**MASON COUNTY PUBLIC SERVICE DISTRICT
MASON COUNTY, WEST VIRGINIA**

CONTRACT #2 - J2Y35 WATER TANK REPLACEMENT

ADDENDUM #2

THRASHER PROJECT #010-10151

SHEET No.
2

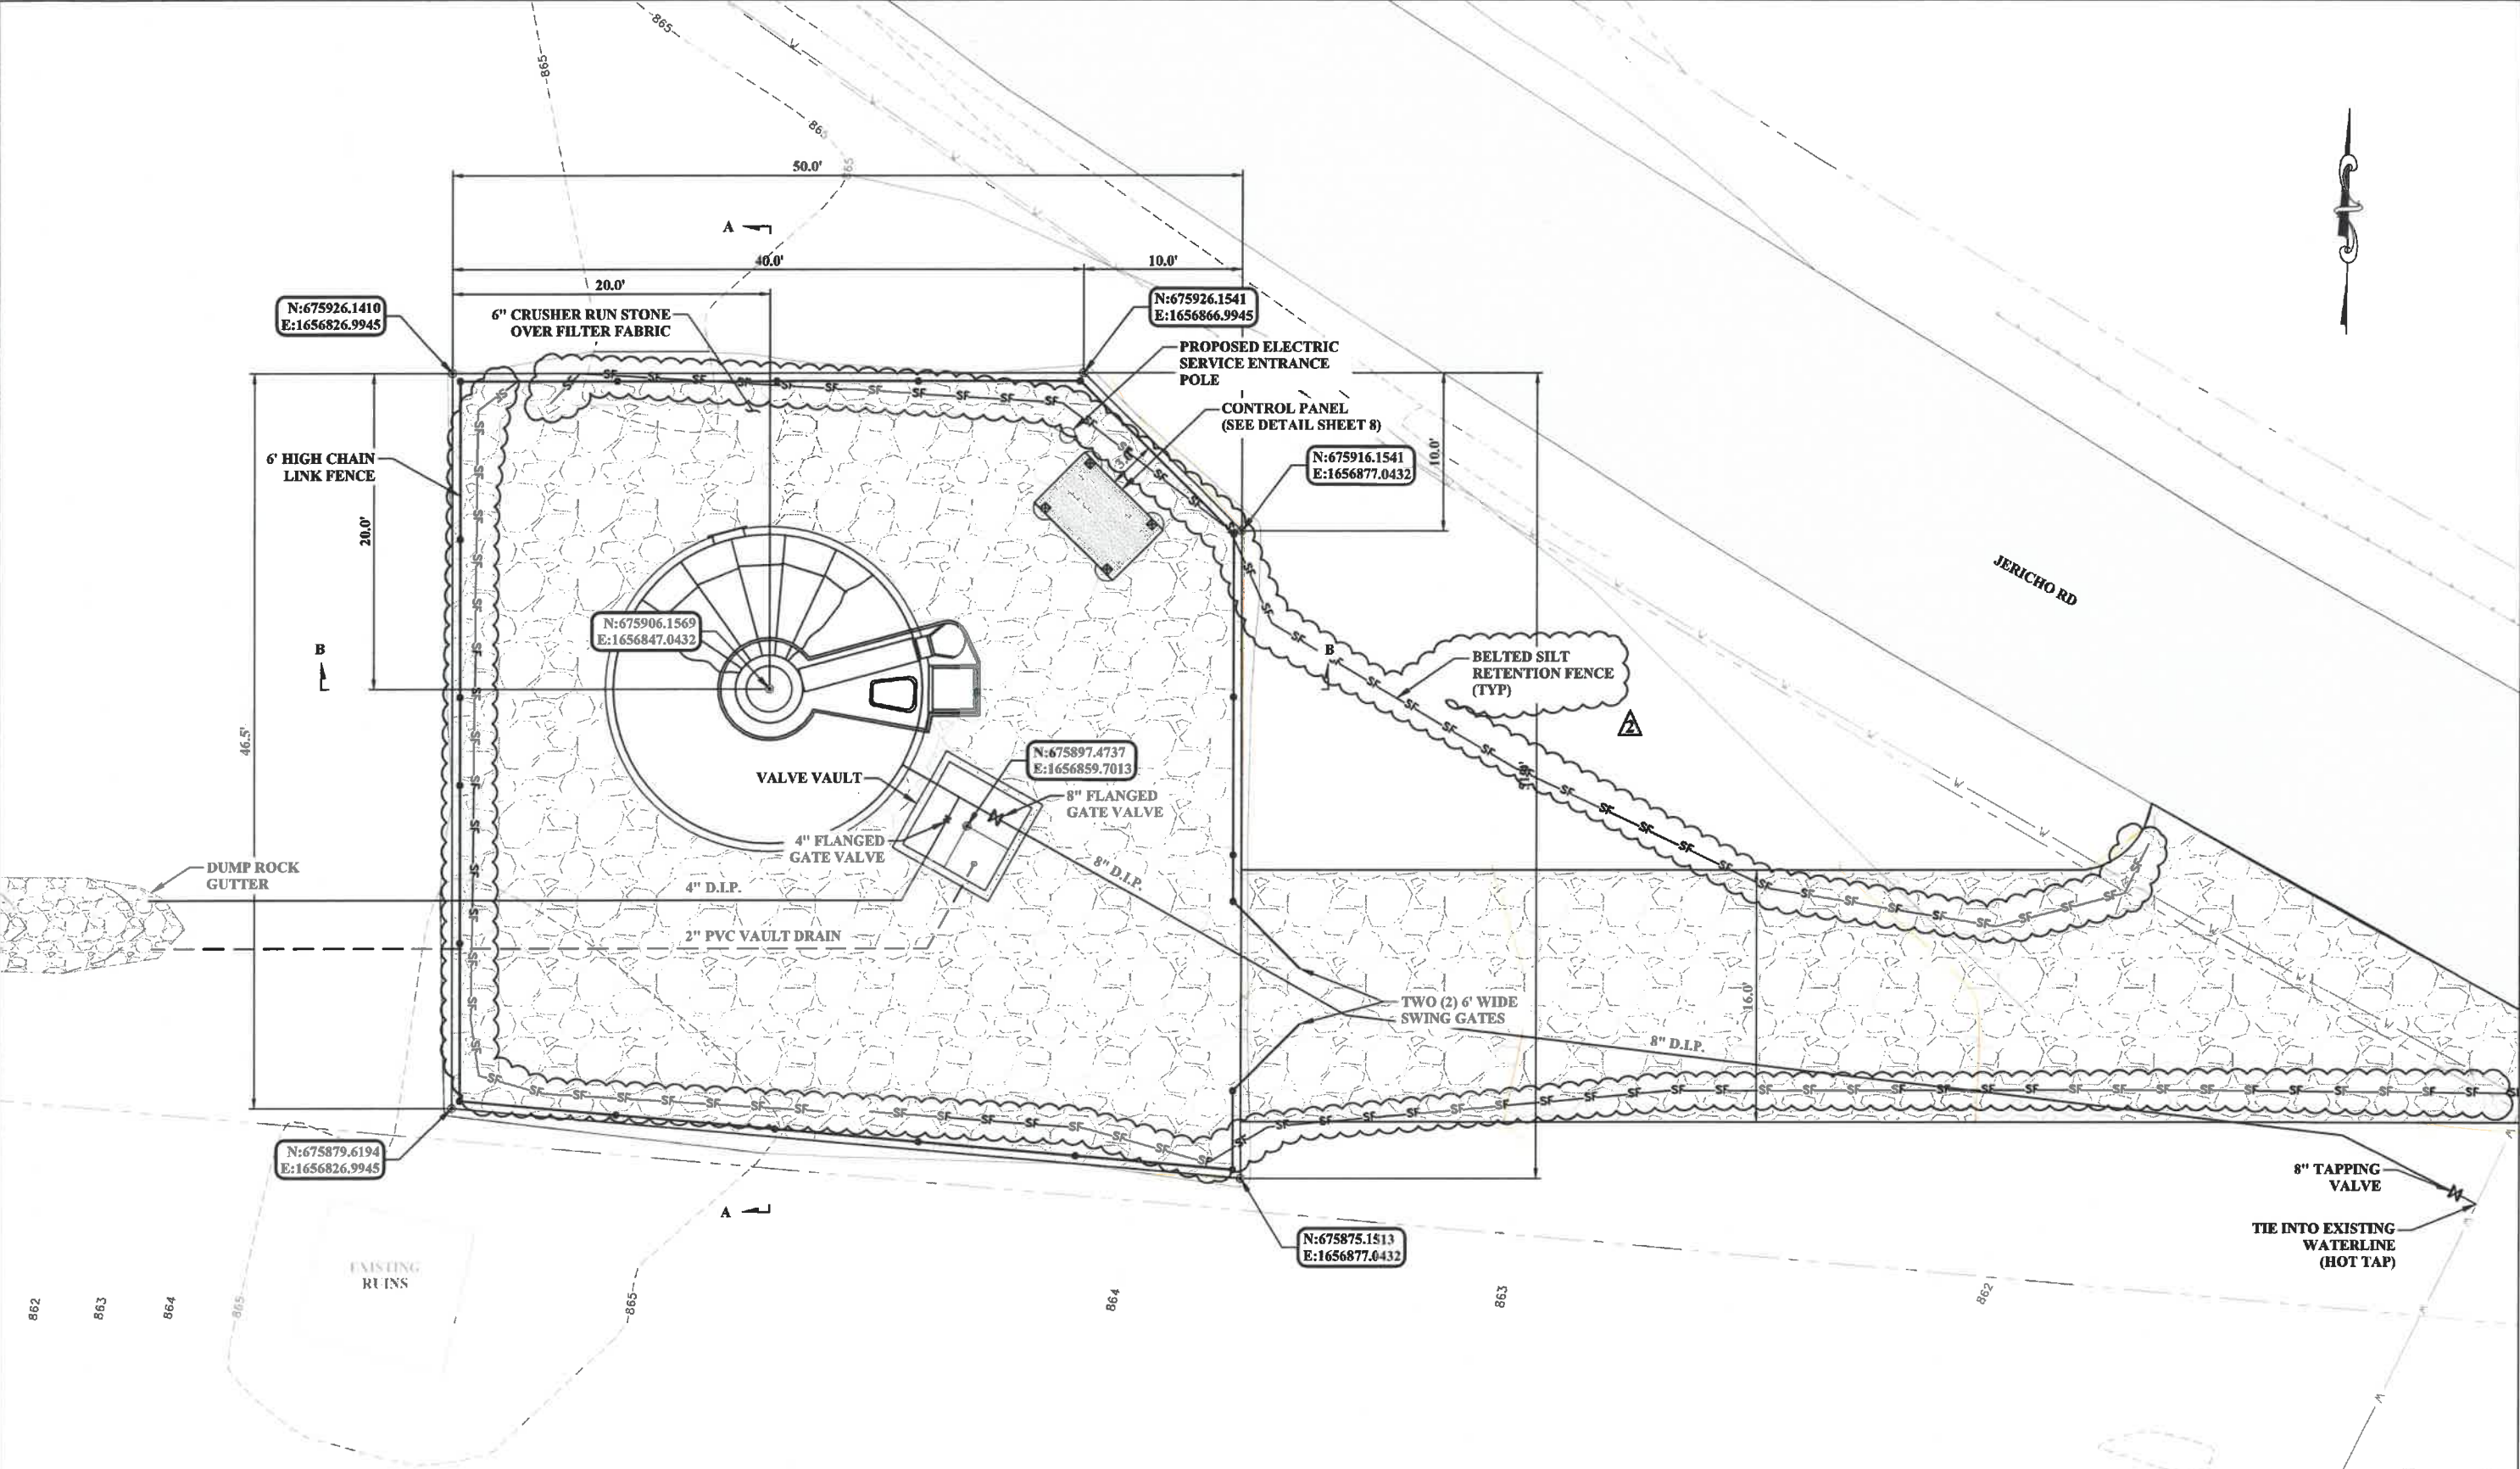
1. Erosion and Sedimentation Controls have been included on Sheets 2 and 9 included with this Addendum #2.

NO.	BY	DATE	DESCRIPTION
2	KMP	11/2022	ADDENDUM #2 - ADDED BELTED SILT RETENTION FENCE

SHEET No.	3
-----------	----------

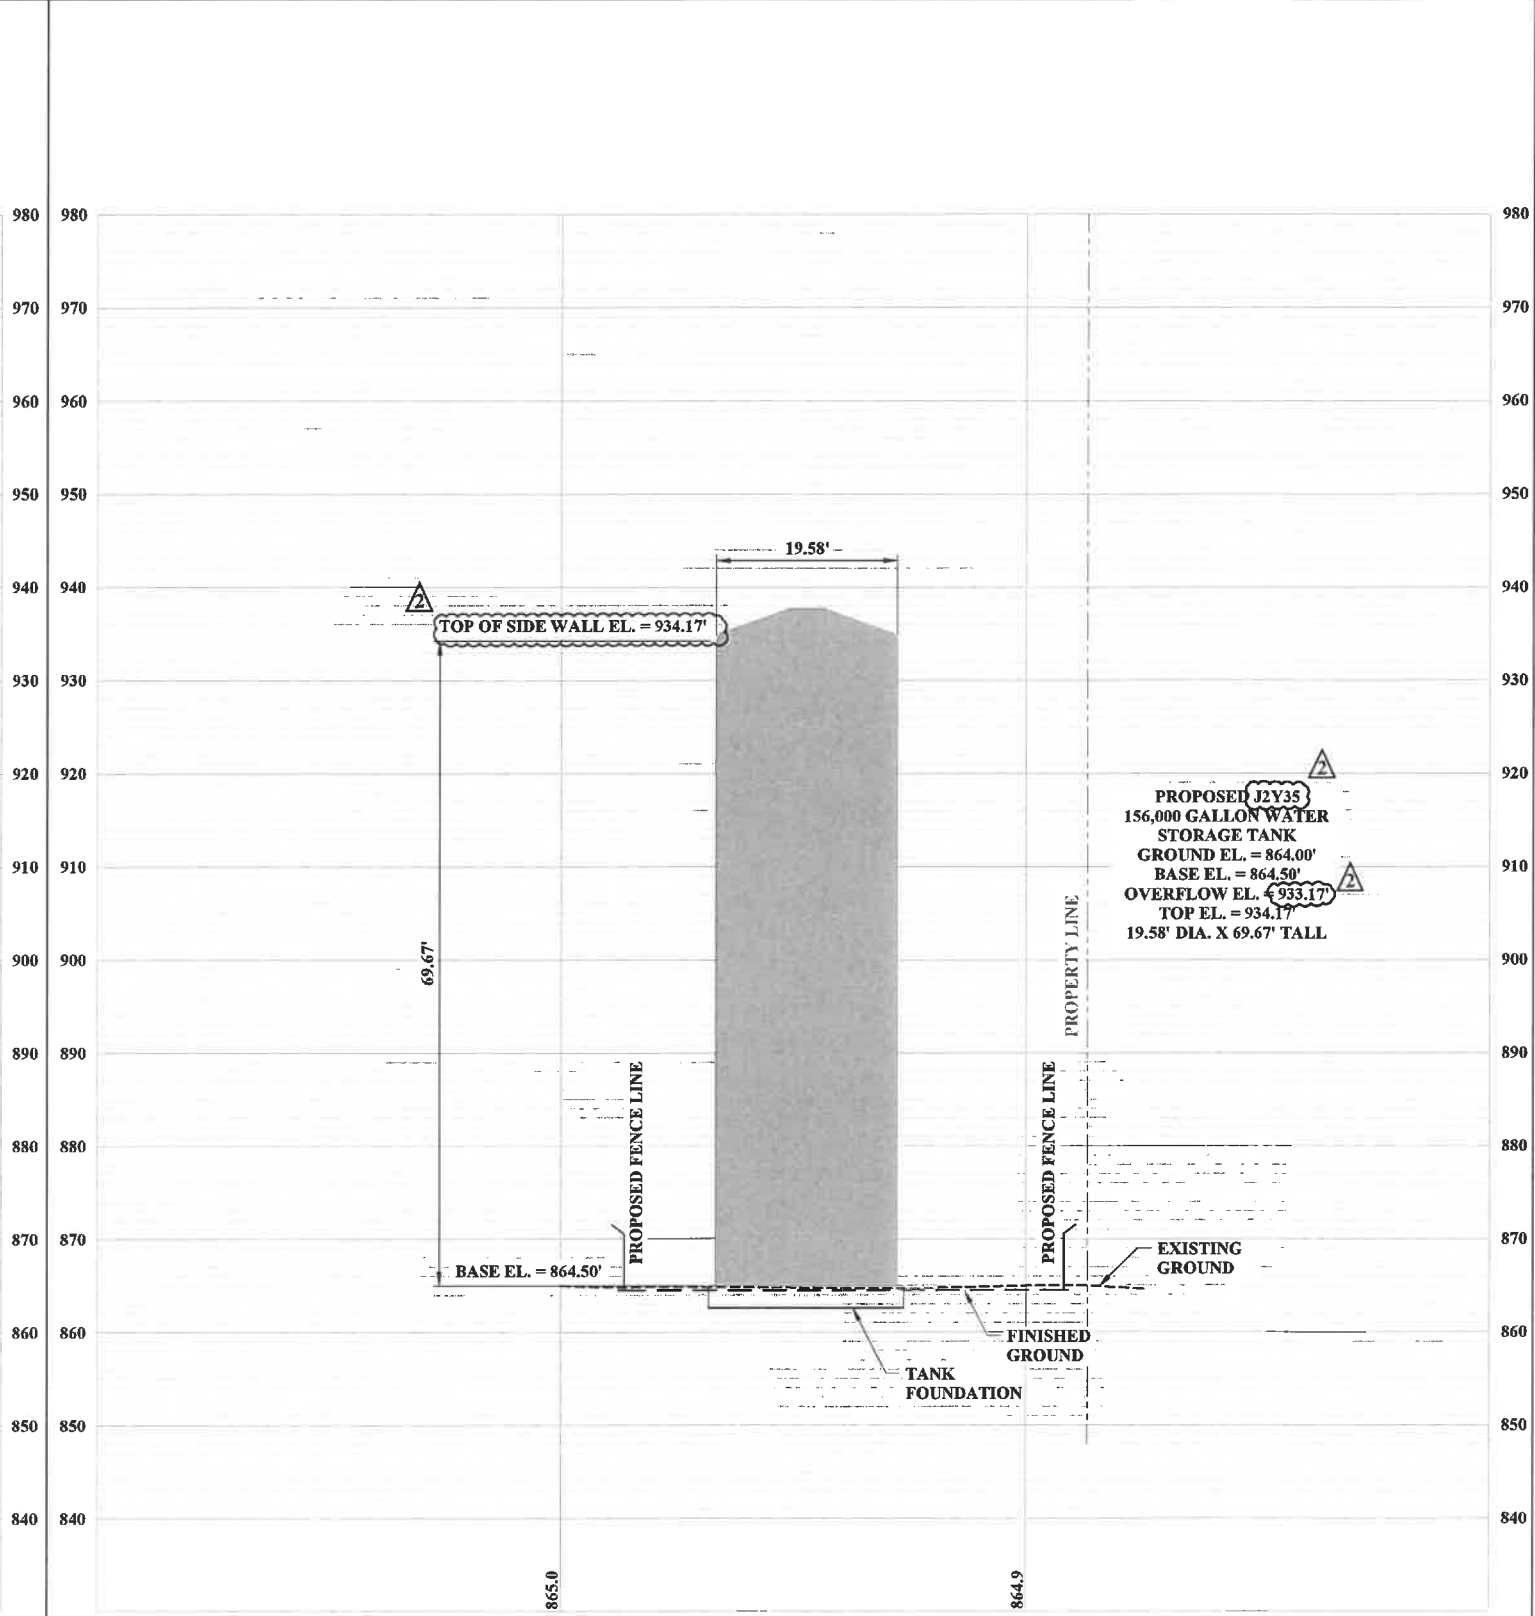
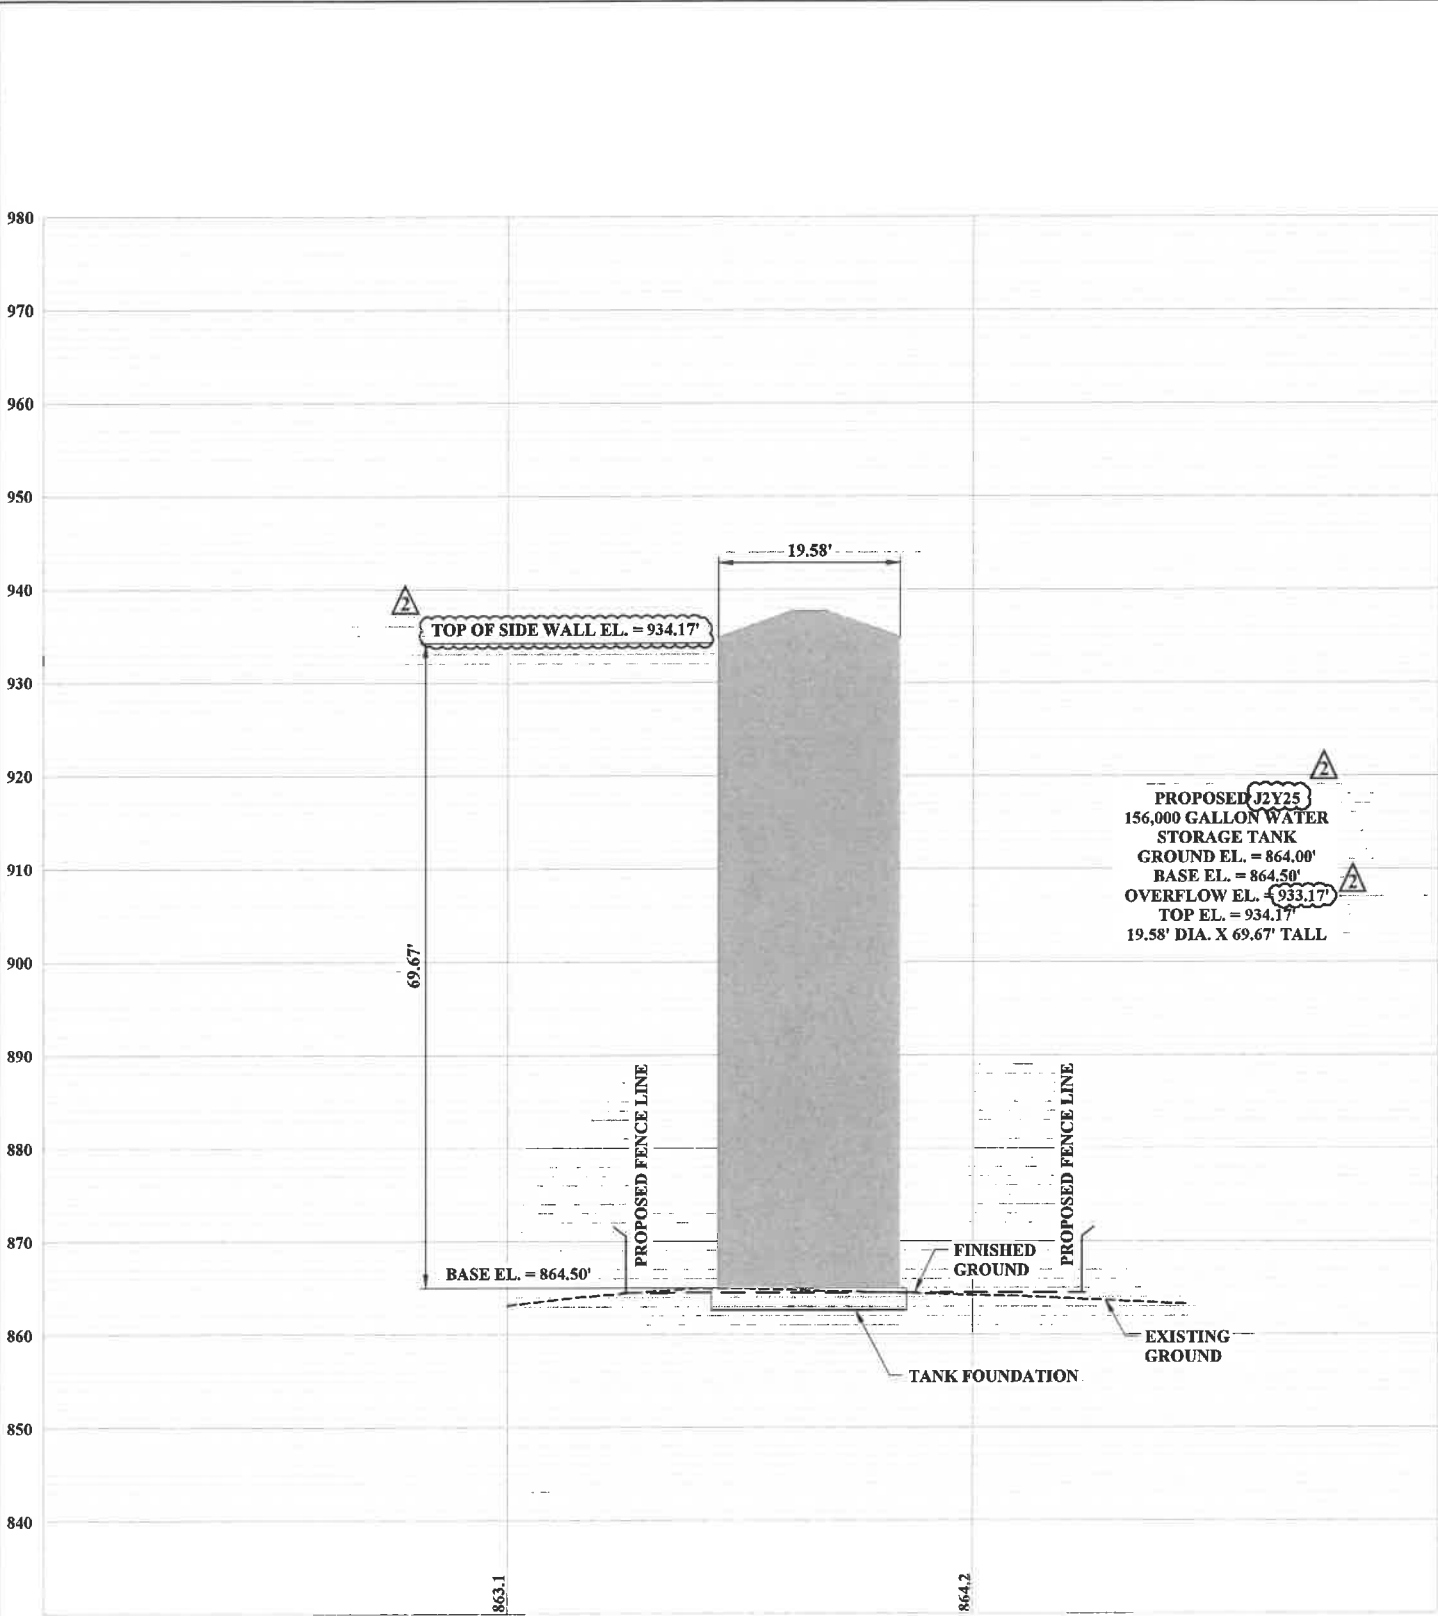
2. What is the Freeboard amount required for the tank?

NO.	BY	DATE	DESCRIPTION
2	KMP	11/2022	ADDENDUM #2 - UPDATED SIDE WALL ELEV. OF TANK

Twelve inches. Refer to Sheet 3 and Sheet 5 included in this Addendum #2.
